Access Audit Site Report

Lake Whitney State Park

Accessibility Evaluation

Inspection Date: 01/20/2022

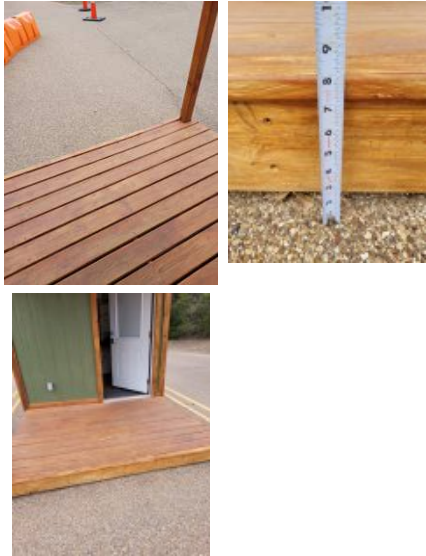
33	Exterior: Parking	[31.918874, -97.3720526]	There are no accessible parking stalls. Each lot where parking is provided for the public as clients, guests or employees, shall provide accessible parking and shall be located on the shortest accessible route of travel from adjacent parking to an accessible entrance. There are a total of (52) parking stalls in the parking lot that could be reasonably associated with this facility. There should be a minimum of (3) accessible stalls with a minimum of (1) being designed as van accessible.	Towash loop - 0 of 52 stalls are accessible	Create three or more 8' accessible parking stalls, with one 5' adjacent access aisle, with proper signage and striping based on the total number of stalls	2015 ABAAS Section: F208.2 2012 TAS Section: 208.2 2010 ADAS Section: 208.2	  	
34	Exterior: Parking	[31.9201011, -97.3688071]	There are no accessible parking stalls. Each lot where parking is provided for the public as clients, guests or employees, shall provide accessible parking and shall be located on the shortest accessible route of travel from adjacent parking to an accessible entrance. There are a total of (4) parking stalls in the parking lot that could be reasonably associated with this facility. There should be a minimum of (1) accessible stalls with a minimum of (1) being designed as van accessible.	White Tail restroom building - 0 of 4 stalls are accessible	Create one or more 8' accessible parking stalls, with one 5' adjacent access aisle, with proper signage and striping based on the total number of stalls	2015 ABAAS Section: F208.2 2012 TAS Section: 208.2 2010 ADAS Section: 208.2

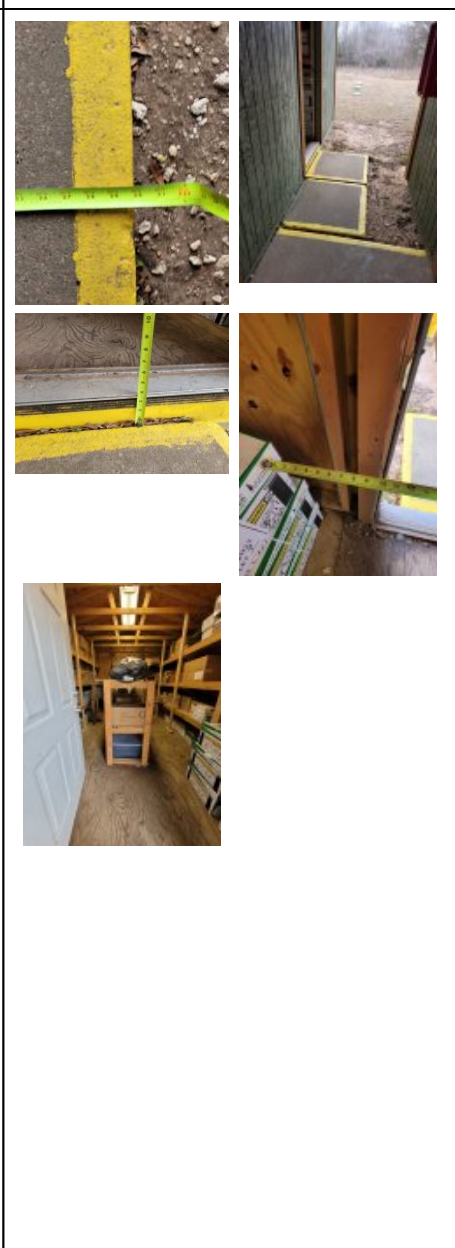
36	Exterior: Parking	[31.9311421 , -97.357022 8]	There are no accessible parking stalls. Each lot where parking is provided for the public as clients, guests or employees, shall provide accessible parking and shall be located on the shortest accessible route of travel from adjacent parking to an accessible entrance. There are a total of (6) parking stalls in the parking lot that could be reasonably associated with this facility. There should be a minimum of (1) accessible stalls with a minimum of (1) being designed as van accessible.	Headquarters - 0 of 6 stalls accessible	Create one or more 8' accessible parking stalls, with one 5' adjacent access aisle, with proper signage and striping based on the total number of stalls	2015 ABAAS Section: F208.2 2012 TAS Section: 208.2 2010 ADAS Section: 208.2		
37	Exterior: Parking	[31.9178973 , -97.360047]	There are no accessible parking stalls. Each lot where parking is provided for the public as clients, guests or employees, shall provide accessible parking and shall be located on the shortest accessible route of travel from adjacent parking to an accessible entrance. There are a total of (25) parking stalls in the parking lot that could be reasonably associated with this facility. There should be a minimum of (1) accessible stalls with a minimum of (1) being designed as van accessible.	Fishing pier at Lakeview - estimated 25 unmarked stalls, lacks accessible marked parking	Create one or more 8' accessible parking stalls, with one 5' adjacent access aisle, with proper signage and striping based on the total number of stalls	2015 ABAAS Section: F208.2 2012 TAS Section: 208.2 2010 ADAS Section: 208.2

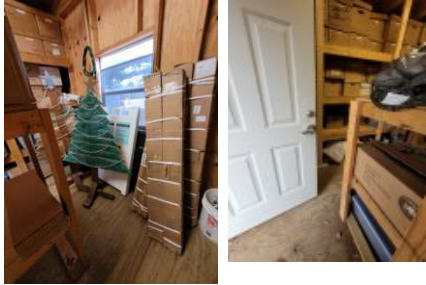
Finding Number	Area Description	Lat/Long	Finding	As Built	Recommendation	Citation	Photos	Figure
38	Headquarters Building: HQ - Employee Spaces	[31.9312969 , -97.356908 8]	Minimum maneuvering clearances at doors and gates shall comply with 404.2.4. Maneuvering clearances shall extend the full width of the doorway and the required latch side or hinge side clearance.	Main office- reduced to less than 2" by counter and cabinets	Provide required maneuvering clearance on push side of door	2015 ABAAS Section: 404.2.4.4, 404.2.4.1 2012 TAS Section: 404.2.4.4, 404.2.4.1 2010 ADAS Section: 404.2.4.4, 404.2.4.1		
39	Headquarters Building: HQ - Employee Spaces	[31.9312832 , -97.356908 8]	Vertical clearance shall be 80 inches (2030 mm) high minimum. Guardrails or other barriers shall be provided where the vertical clearance is less than 80 inches (2030 mm) high. The leading edge of such guardrail or barrier shall be located 27 inches (685 mm) maximum above the finish floor or ground. EXCEPTION: Door closers and door stops shall be permitted to be 78 inches (1980 mm) minimum above the finish floor or ground.	main office - 79.25" above finished floor; 31" width	Replace doors with doors having 80" overhead clearance Widen doors to minimum 32"	2015 ABAAS Section: 307.4, 307.4 EXCEPTION 2012 TAS Section: 307.4, 307.4 Exception 2010 ADAS Section: 307.4, 307.4 Exception

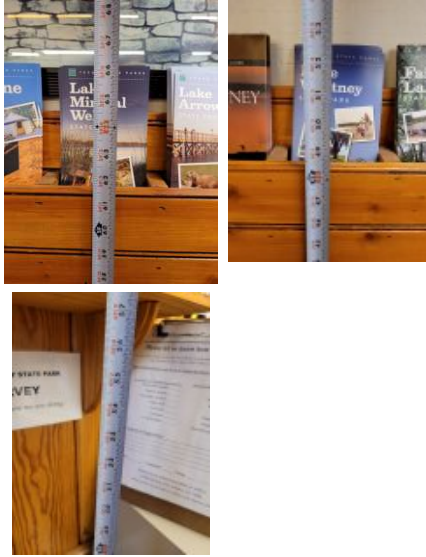
Finding Number	Area Description	Lat/Long	Finding	As Built	Recommendation	Citation	Photos	Figure
40	Headquarters Building: HQ - Employee Spaces	[31.9312832 , -97.356908 8]	Minimum maneuvering clearances at doors and gates shall comply with 404.2.4. Maneuvering clearances shall extend the full width of the doorway and the required latch side or hinge side clearance. Maneuvering clearances shall have a max slope of 2.08%. Door openings shall provide a clear width of 32 inches (815 mm) minimum. Clear openings of doorways with swinging doors shall be measured between the face of the door and the stop, with the door open 90 degrees. Openings more than 24 inches (610 mm) deep shall provide a clear opening of 36 inches (915 mm) minimum. There shall be no projections into the required clear opening width lower than 34 inches (865 mm) above the finish floor or ground. Projections into the clear opening width between 34 inches (865 mm) and 80 inches (2030 mm) above the finish floor or ground shall not exceed 4 inches (100 mm). The threshold has a vertical change greater than 1/4 inch high. Carpet or carpet tile shall be securely attached	employee exterior - 29" width, lacks maneuvering clearance on push side, 4.75" change in elevation, mat not secure	For all doors along the public circulation route, provide required maneuvering clearance on push and pull side of doors. For all doors along the public circulation route, replace doors with doors having 80" overhead clearance and 32" clear width. For all doors along the public circulation route, repair, bevel, or ramp CILs at door entries to max .25". Carpet or carpet tile shall be securely attached	2010 ADAS Section: 404.2.3, 404.2.7, 404.2.4, 404.2.11, 404.2.11 Exception

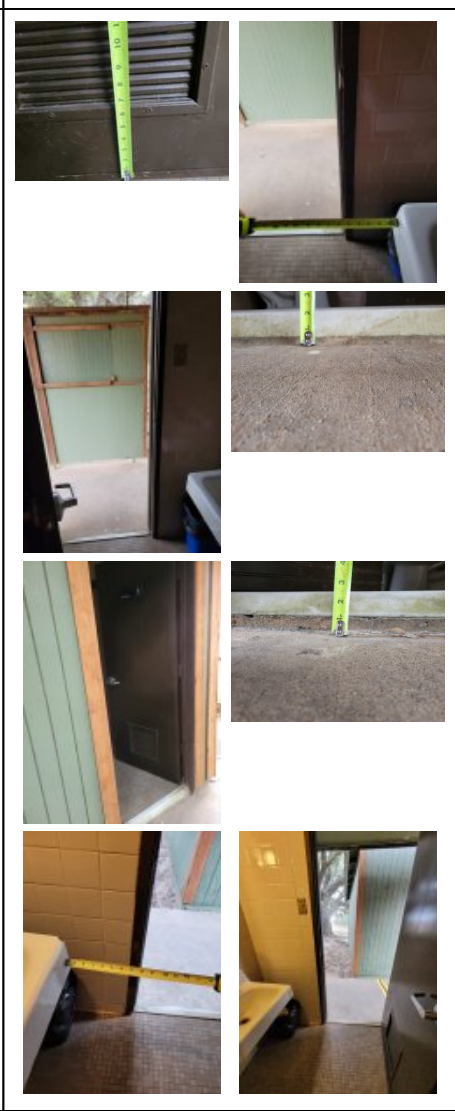
Finding Number	Area Description	Lat/Long	Finding	As Built	Recommendation	Citation	Photos	Figure
46	Headquarters Building: HQ - Employee Spaces	[31.9312923 , -97.356908 8]	Spaces and elements within employee work areas shall only be required to comply with 206.2.8, 207.1, and 215.3 and shall be designed and constructed so that individuals with disabilities can approach, enter, and exit the employee work area. Employee work areas, or portions of employee work areas, other than raised courtroom stations, that are less than 300 square feet (28 m2) and elevated 7 inches (180 mm) or more above the finish floor or ground where the elevation is essential to the function of the space shall not be required to comply with these requirements or to be on an accessible route.	Storage - 30" width, 4" step up, maneuvering clearance on pull side reduced by storage and shelf, maneuvering clearance on push side reduced by lack of landing or clear floor space	For employee spaces, relocate storage, furniture, and other obstacles at doorways to provide approach, enter and exit at the employee space. Provide required maneuvering clearance on push and pull side of doors. Replace doors with doors having 80" overhead clearance and 32" clear width. Repair, bevel, or ramp CILs at door entries to max .25".	2015 ABAAS Section: F203.9 2012 TAS Section: 203.9 2010 ADAS Section: 203.9

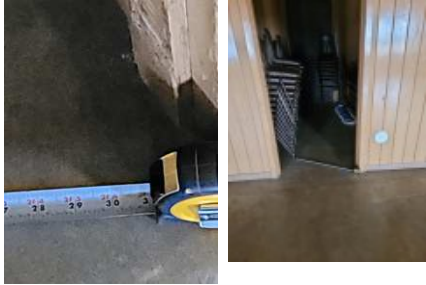
53	Headquarters Building: HQ - Public Spaces	[31.9313329, -97.3568813]	The 30 inches minimum by 48 inches minimum clear floor space required at the operable part is not flat (2% or 1:48 maximum slope) in all directions. Changes in level are not permitted at required clear floor or ground space except that slopes not steeper than 1:48 shall be permitted.	8.3% at clear floor space for park library exchange	Correct or repair slope in CFS to max 2.08%	2015 ABAAS Section: 305.2 2012 TAS Section: 305.2 2010 ADAS Section: 305.2

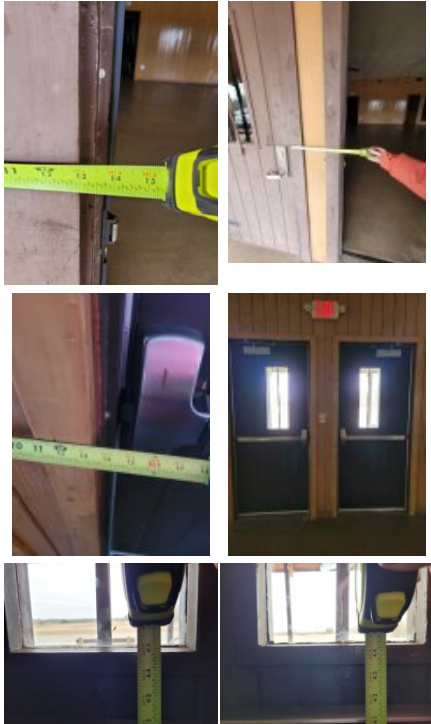
Finding Number	Area Description	Lat/Long	Finding	As Built	Recommendation	Citation	Photos	Figure
58	Headquarters Building: HQ - Restroom	[31.9312923 , -97.3569356]	Minimum maneuvering clearances at doors and gates shall comply with 404.2.4. Maneuvering clearances shall extend the full width of the doorway and the required latch side or hinge side clearance. Maneuvering clearances shall have a max slope of 2.08%. The threshold has a vertical change greater than 1/4 inch high. The threshold at a doorway shall be no higher than 1/2 inch. Changes in level between 1/4 inch and 1/2 inch must be beveled at 1:2 or less. 1/4 inch is the maximum vertical rise. The bottom 10 inches on the push side must be smooth and free of obstructions (hold open devices). Opening hardware must be mounted between 30 and 44 inches above the floor or ground.	Women's restroom - 5.5" maneuvering clearance on pull side due to sink, 2" change in elevation, 6.5" above finished floor door grate at bottom of door; Men's restroom - 2.5" change in elevation, 8" maneuvering clearance due to sink on pull side	For all doors along the public circulation route, provide required maneuvering clearance on push and pull side of doors. For all doors along the public circulation route, repair, bevel, or ramp CILs at door entries to max .25". For all doors along the public circulation route, provide kick plate on push side of door from floor to 10" aff.	2010 ADAS Section: 404.2.3, 404.2.7, 404.2.4, 404.2.11, 404.2.11 Exception

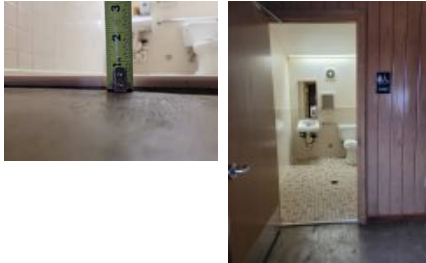
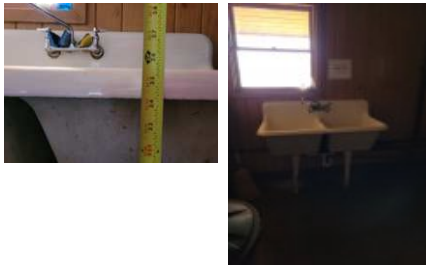
62	Dining Hall: Dining Hall	[31.924422, -97.370126 8]	The top of the work surface is not within a compliant height range. The tops of tables and counters shall be 28 inches to 34 inches from the floor or ground.	Tables in storage, unable to measure	Ensure at least one table is 28" to 34" aff with required knee and toe clearances	2015 ABAAS Section: 902.3 2012 TAS Section: 902.3 2010 ADAS Section: 902.3

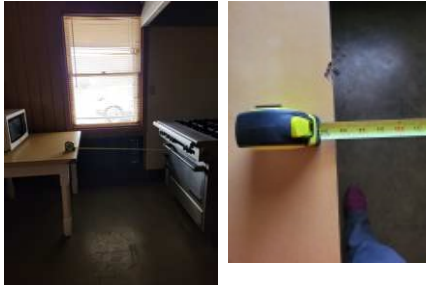
65	Dining Hall: Dining Hall	[31.9244266 , -97.370105 3]	The door operating hardware is not accessible. Hand-activated door opening hardware, handles, pulls, latches, locks, and other operating devices on accessible doors shall have a shape that is easy to grasp with one hand and does not require tight grasping, tight pinching or twisting of the wrist to operate. Hardware shall be 34 inches minimum and 48 inches maximum above the finish floor or ground.	Storage - knob hardware	Replace hardware with lever hardware or hardware operable without a tight pinch or grasp	2015 ABAAS Section: 404.2.7 2012 TAS Section: 404.2.7 2010 ADAS Section: 404.2.7

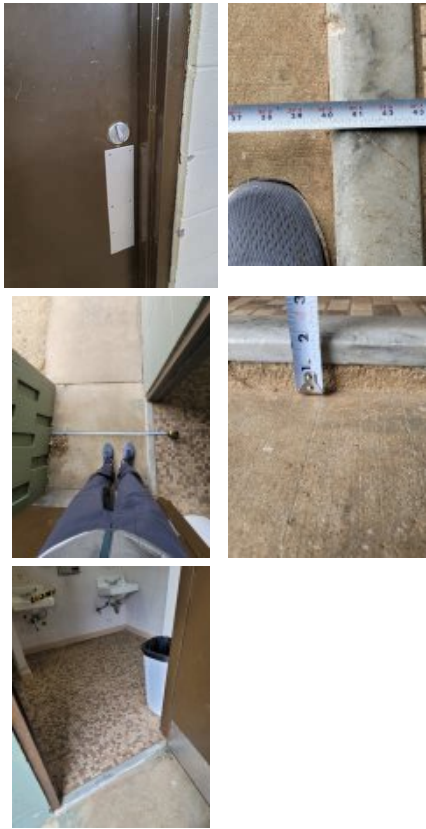
88	Park Site: Air Strip	[31.927081, -97.3610072]	Picnic tables shall provide at least one wheelchair space for each 24 linear feet (7320 mm) of usable table surface perimeter. Wheelchair spaces shall be 30 inches (760 mm) minimum by 48 inches (1220 mm) minimum. Wheelchair spaces shall be positioned for a forward approach to the table and provide knee and toe clearance complying with 306 under the table	Covered area - 0 of 3 picnic tables are of accessible design	Replace picnic table with one of an accessible design as a smart practice	2015 ABAAS Section: 1011.4.2

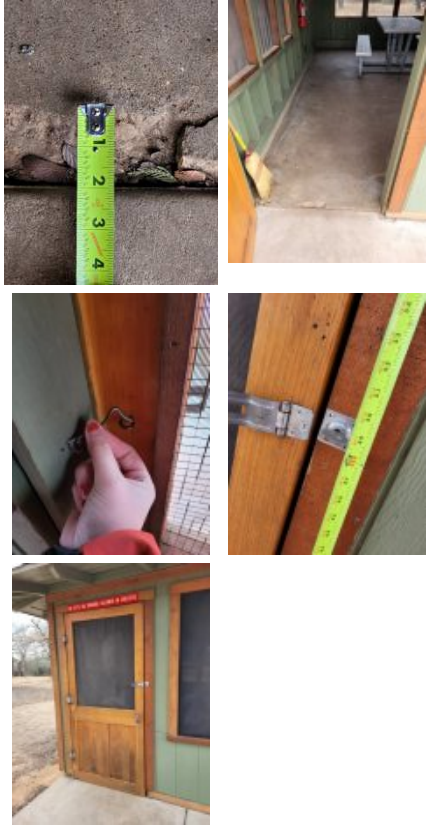
99	Horseshoe Camping Loop: Horseshoe - Men's Restroom	[31.9285083, -97.36528]	This restroom is not accessible. Where existing toilet rooms or bathing rooms do not comply, directional signs indicating the location of the nearest accessible toilet room or bathing room within the facility shall be provided. Signs shall include the International Symbol of Accessibility. Where existing toilet rooms or bathing rooms do comply), the accessible toilet rooms or bathing rooms shall be identified by the International Symbol of Where clustered single user toilet rooms or bathing facilities are permitted, accessible toilet rooms or bathing facilities shall be identified by the International Symbol of Accessibility unless all toilet rooms and bathing facilities are accessible.	Lacks directional sign to accessible restroom	Restroom not accessible, acquire and mount signage directing patrons to accessible restroom	2015 ABAAS Section: F216.8 2012 TAS Section: 216.8 2010 ADAS Section: 216.8

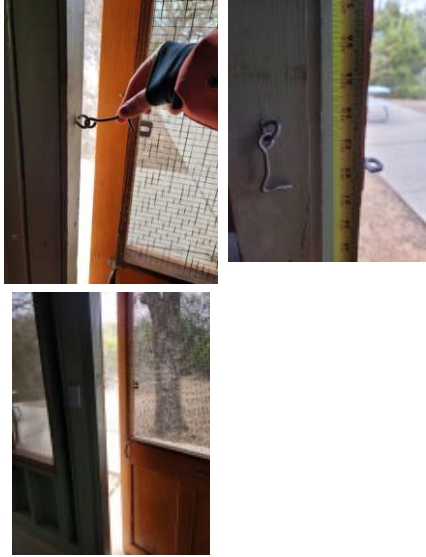
Finding Number	Area Description	Lat/Long	Finding	As Built	Recommendation	Citation	Photos	Figure
102	Horseshoe Camping Loop: Horseshoe - Men's Restroom	[31.9285128 , -97.3652706]	There are no accessible bathing or shower facilities. Where facilities for bathing are provided for the public, clients or employees, including showers or bathtubs, at least one shower or bathtub and support facilities such as lockers, and not less than 1 percent of all facilities, shall be accessible.	23" entry width to showers, showers are not accessible	Create an accessible shower in locker/bathing room	2015 ABAAS Section: F213.3.6 2012 TAS Section: 213.3.6 2010 ADAS Section: 213.3.6		
103	Horseshoe Camping Loop: Horseshoe - Men's Restroom	[31.9285089 , -97.3652799]	Minimum maneuvering clearances at doors and gates shall comply with 404.2.4. Maneuvering clearances shall extend the full width of the doorway and the required latch side or hinge side clearance. The threshold has a vertical change greater than 1/4 inch high. The threshold at a doorway shall be no higher than 1/2 inch. Changes in level between 1/4 inch and 1/2 inch must be beveled at 1:2 or less. 1/4 inch is the maximum vertical rise. The sweep period for doors with closers shall be adjusted so that from an open position of 70 degrees, the door will take at least 3 seconds to move to a point 3 inches from the latch, measured to the leading edge of the door. Hand-activated door opening hardware, handles, pulls, latches, locks, and other operating devices on accessible doors shall have a shape that is easy to grasp with one hand and does not require tight grasping, tight pinching or twisting of the wrist to operate. Hardware shall be 34 inches minimum and 48 inches maximum above the finish floor or ground.	Pinch hardware, maneuvering clearance reduced to 40", 1.75" change in elevation, fast closing	For all doors along the public circulation route, provide required maneuvering clearance on push and pull side of doors For all doors along the public circulation route, repair, bevel, or ramp CILs at door entries to max .25" For all doors along the public circulation route, inspect, adjust, and maintain closing speed on door closers For all doors along the public circulation route, replace hardware with lever hardware or hardware operable without a tight pinch or grasp	2010 ADAS Section: 404.2.3, 404.2.7, 404.2.4, 404.2.11, 404.2.11 Exception

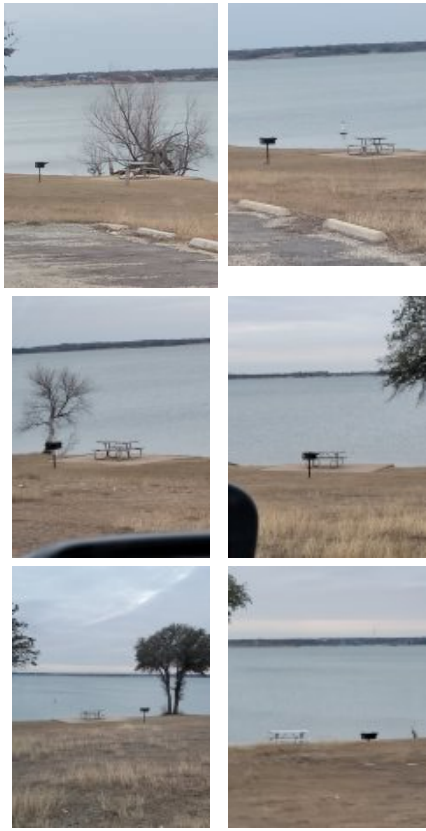
Finding Number	Area Description	Lat/Long	Finding	As Built	Recommendation	Citation	Photos	Figure
106	Horseshoe Camping Loop: Horseshoe - Women's Restroom	[31.9285197, -97.3652572]	There are no accessible bathing or shower facilities. Where facilities for bathing are provided for the public, clients or employees, including showers or bathtubs, at least one shower or bathtub and support facilities such as lockers, and not less than 1 percent of all facilities, shall be accessible.	Lacks accessible shower	Create an accessible shower in locker/bathing room	2015 ABAAS Section: F213.3.6 2012 TAS Section: 213.3.6 2010 ADAS Section: 213.3.6		
107	Horseshoe Camping Loop: Horseshoe - Women's Restroom	[31.9285231, -97.3652518]	Minimum maneuvering clearances at doors and gates shall comply with 404.2.4. Maneuvering clearances shall extend the full width of the doorway and the required latch side or hinge side clearance. Door openings shall provide a clear width of 32 inches (815 mm) minimum. Clear openings of doorways with swinging doors shall be measured between the face of the door and the stop, with the door open 90 degrees. Openings more than 24 inches (610 mm) deep shall provide a clear opening of 36 inches (915 mm) minimum. There shall be no projections into the required clear opening width lower than 34 inches (865 mm) above the finish floor or ground. Projections into the clear opening width between 34 inches (865 mm) and 80 inches (2030 mm) above the finish floor or ground shall not exceed 4 inches (100 mm). The threshold has a vertical change greater than 1/4 inch high.	77.5" overhead at closer, 2" change in level, maneuvering clearance reduced to 40", 22 lbf	For all doors along the public circulation route, provide required maneuvering clearance on push and pull side of doors For all doors along the public circulation route, replace doors with doors having 80" overhead clearance and 32" clear width For all doors along the public circulation route, repair, bevel, or ramp CILs at door entries to max .25"	2010 ADAS Section: 404.2.3, 404.2.7, 404.2.4, 404.2.11, 404.2.11 Exception

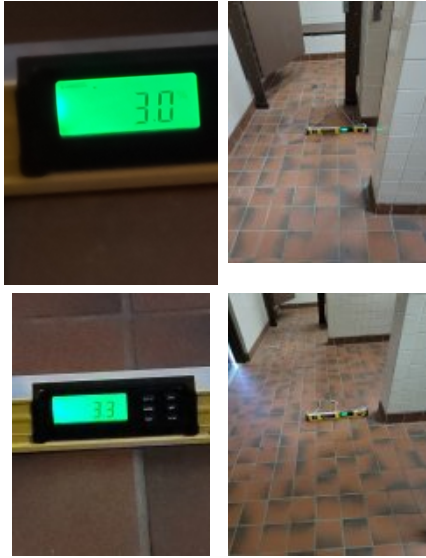
146	White Tail Camping Loop: White Tail - Men's Restroom	[31.920191, -97.3688996]	This restroom is not accessible. Where existing toilet rooms or bathing rooms do not comply, directional signs indicating the location of the nearest accessible toilet room or bathing room within the facility shall be provided. Signs shall include the International Symbol of Accessibility. Where existing toilet rooms or bathing rooms do comply, the accessible toilet rooms or bathing rooms shall be identified by the International Symbol of Where clustered single user toilet rooms or bathing facilities are permitted, accessible toilet rooms or bathing facilities shall be identified by the International Symbol of Accessibility unless all toilet rooms and bathing facilities are accessible.	Lacks directional signage	Restroom not accessible, acquire and mount signage directing patrons to accessible restroom	2015 ABAAS Section: F216.8 2012 TAS Section: 216.8 2010 ADAS Section: 216.8
